The Sizewell C Project

5.6 Sizewell Link Road Flood Risk Assessment Addendum

Revision: 2.0
Applicable Regulation: Regulation 5(2)(q)
PINS Reference Number: EN010012

July 2021

Plate 4.2: Cross-section of portal culvert at crossing 1 (extract from drawing no. SZC-AD0310-WSP-SLRHDG-ZZ0000-DRW-HCD-300002)

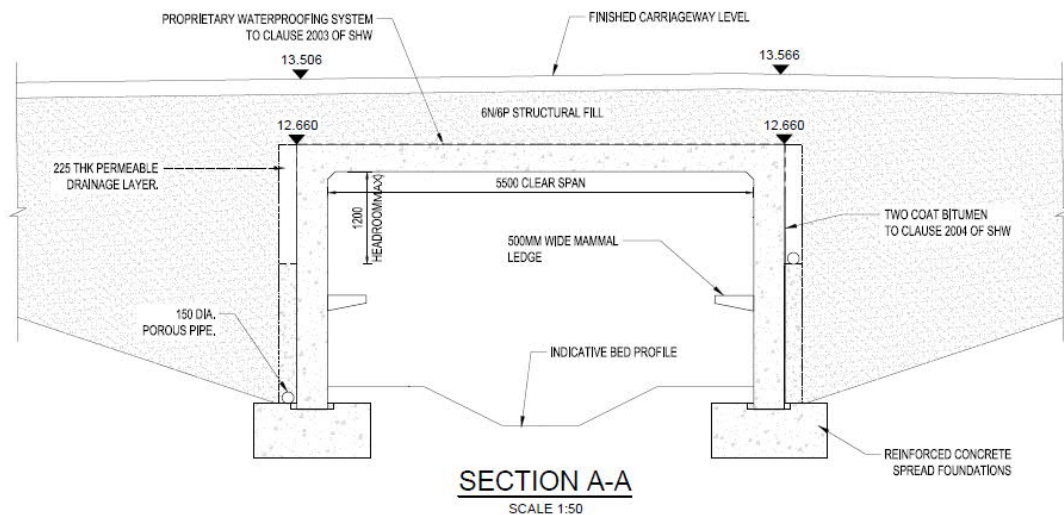
"Report and proposed crossing layouts imply basic portal culverts have been used at all the crossings which is not correct. There has been little evidence that the knowledge of flood risk has informed and evidenced the design of the culverts and associated flood relief structures and mammal ledges."

- 4.2.6 SZC Co. ~~made propose~~ a change to the design of the culvert at crossing 1, where in the Application, a T-shaped concrete cross-section through the culvert was proposed. The latest design assumes a portal culvert will be included within the diverted channel keeping the 1 in 3 bank slopes but fitting the culvert by cutting into the banks. The channel bed remains 1m wide and the banks will be at least 0.5m above the bed level. A cross-section through the proposed portal culvert crossing is shown in **Plate 4.2**.

- 4.2.7 Mammal ledges would be provided on the sides of the crossing (**Plate 4.2**) at a minimum level of 10.7mAOD within the portal culvert and connected to the ground levels outside of the culvert to provide a continuous path. Initial modelling results showed that the maximum flood levels are below the mammal ledges and culvert soffit level, considering the

Plate 4.6: Maximum flood depth in the with scheme scenario for crossings 1 and 2 – 1 in 100-year event with 65% climate change (extract from Figure B1.9 in APPENDIX C:)

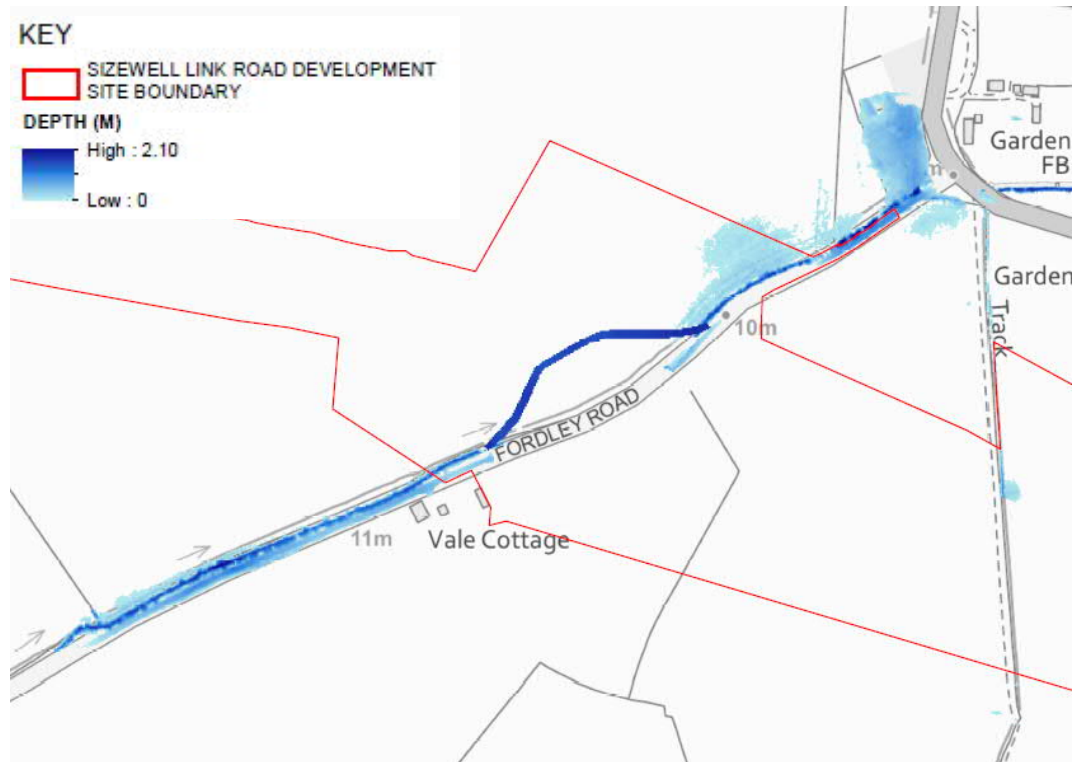
" There are missing elements from the hydraulic model which mean the evidence to support the FRA is lacking in the detail we would expect. It appears as though some aspects of the FRA are based on outline design rather than final designs and some aspects have not been properly considered at all.[...] Flood risk in the baseline and 'with crossing' scenarios has not been mapped so it's very difficult to properly understand third party impacts, particularly where there are out of bank flows such as at SW1 and SW3."

4.2.24 **Plate 4.6** ~~Plate 4.6~~ shows that there is very limited out of bank flooding along the watercourse at crossing 2, with a maximum flood depth of 0.2m for the 1 in 100-year event with 65% climate change, and the majority of the flood water is contained within the channel.

Plate 4.25: Difference in maximum flood depth for crossing 7 – 1 in 100-year event with 35% climate change (extract from Figure C7.8 in APPENDIX C: APPENDIX C)

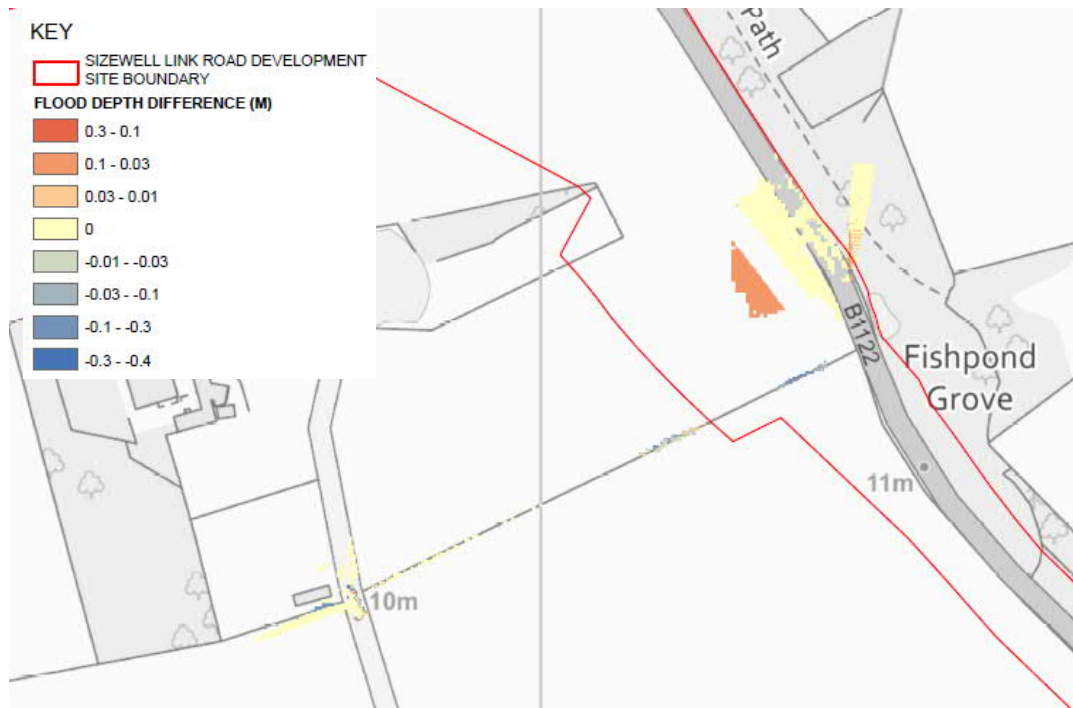
- 3.6.2 The Environment Agency, in their response to the Application, states:
- “No flood risk assessment of proposed crossing at SW7. FRA does not show the road will be safe for its lifetime without increasing flood risk elsewhere” [...].*

4.6.124.6.13 The difference in flood depth between the baseline and post-development scenarios for the 1 in 100-year with 35% climate change allowance is presented in **Plate 4.25**, showing that the maximum increase, immediately upstream of the Sizewell link road embankment (within the site boundary), within the floodplain is up to 0.1m with no significant change in flood depth elsewhere.

4.6.14 There is no impact on flood depth near the residential property upstream of the proposed development. The property is situated approximately 300m upstream of the proposed development at around 10.3mAOD, as observed from LiDAR. Based on the modelling results (Table 4.6~~Table 4.6~~), it is likely that, in the baseline scenario, the property may be flooded in the 1 in 100-year + 65% climate change event. However, there is no increase in flood risk at this property due to the proposed development.
